ADDENDUM NOTICE

Addendum #: 5

Bid No: T24-388

**Description: General Contracting Services for New Fire Station 7-1 Facility
Renewal**

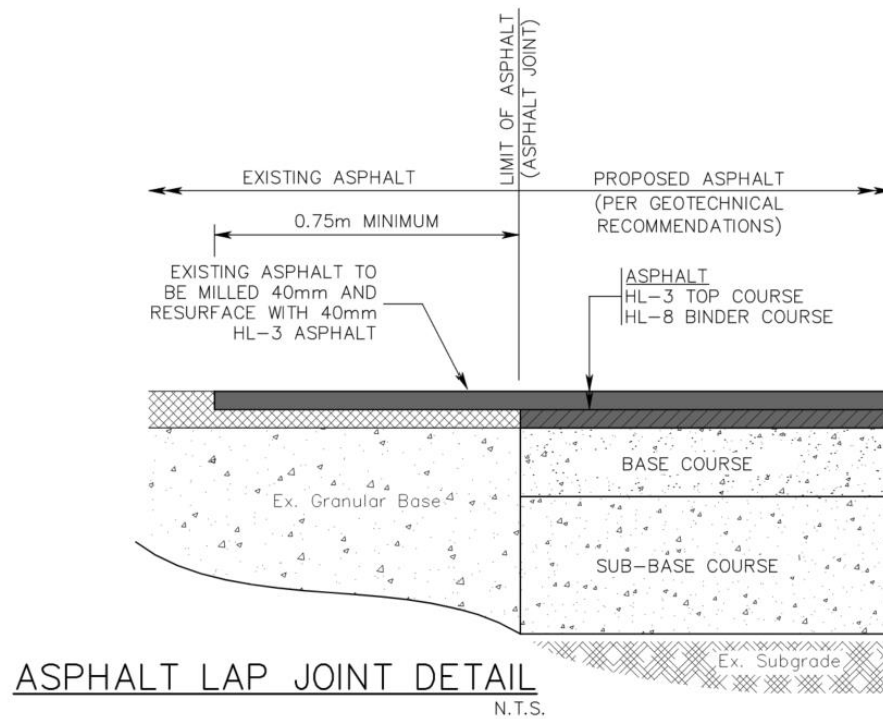
1. Requested to provide the Geotech and Chemical analysis reports.
2. Kindly requested to include Cash Allowance to remove and dispose offsite Hazardous or contaminated soil in the Bid Form?
3. In Dwg.C1.2 Sanitary Cleanout backfill as per Geotech Recommendations, would you please let us know which report to refer or provide the backfill material details.

4. Along with new asphalt paving any lap joints are required? if so please provide the details of the lap joint.

1. Refer to Architectural Supplementary Documents Submitted for Tender. In it you will find the “Terraprobe – Geotech Investigation Report”.
2. Refer to Architectural Specification Section 01 21 00 allowances. Cash Amount shown on Table 1.2.9.1 includes the removal and disposal of hazardous materials (DSS removal).
3. Refer to Architectural Supplementary Documents Submitted for Tender. In it you will find the “Terraprobe – Geotech Investigation Report”.
- 4.
